## Determination 2019/014

### The refusal to issue a code compliance certificate due to concerns about weatherboard fixings to a house at 34 Reotahi Road, Whangarei Heads

**Figure 1: Weatherboard installation (not to scale)**

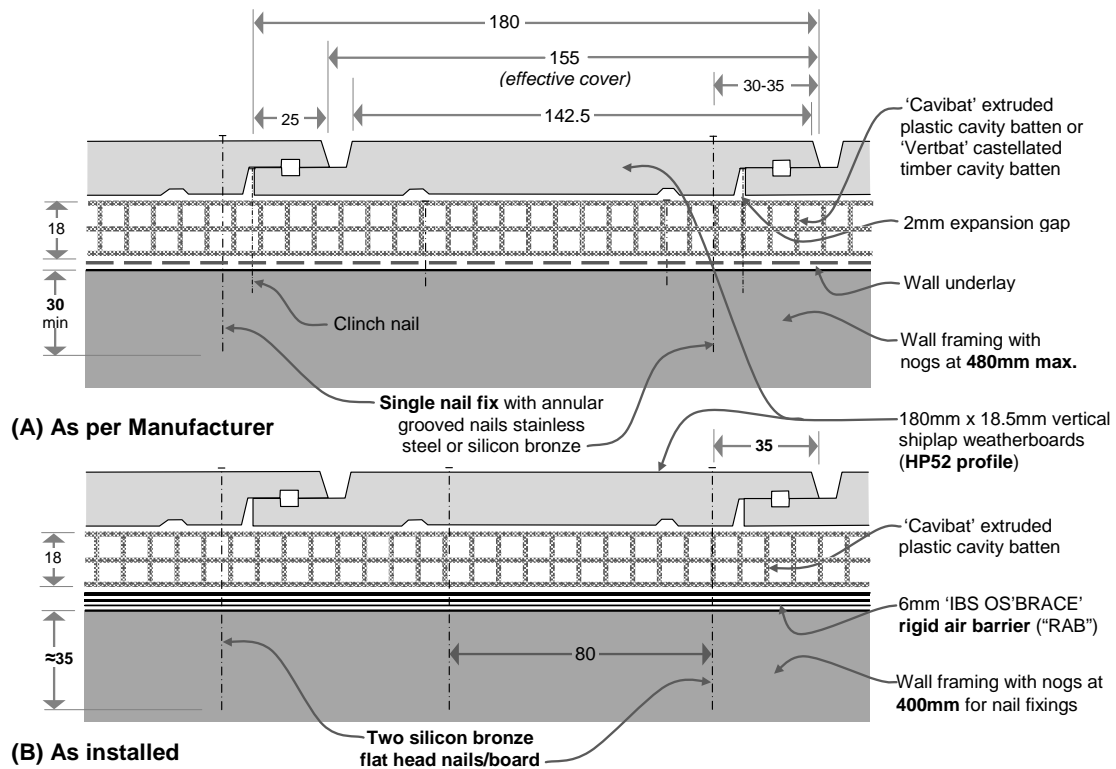
2.4.1 The expert's investigations show that installed weatherboards are as indicated in the sketch in Figure 1(B). This can be compared to Figure 1(A), which aligns with the manufacturer's instructions.

2.4.2 Although the type/size of fixings and the alignment of weathergrooves appears consistent in Figure 1, significant differences are as follows:

- Sketch 1(A): the specification calls for a single nail per board at 480mm maximum centres vertically, fixed through cavity battens and building wrap, with the nails penetrating 30mm minimum into the framing
- Sketch 1(B): the installed cladding is nailed with two nails per board at 400mm centres vertically, through extruded plastic cavity battens and 6mm thick rigid air barrier into the framing, with the nails penetrating 35mm into the framing.

6.3.2 Taking account of the above, I have reasonable grounds to conclude that the weatherboards installed to the exterior walls of this particular house are adequate in these particular circumstances.

- 7.1 In accordance with section 188 of the Building Act 2004, I hereby determine that:
- the weatherboard fixing system as constructed complies with Clauses B2 Durability and E2 External moisture of the Building Code, and
  - I reverse the authority's decision to refuse the code compliance certificate, and require the authority to make a new decision taking into account the findings of this determination.
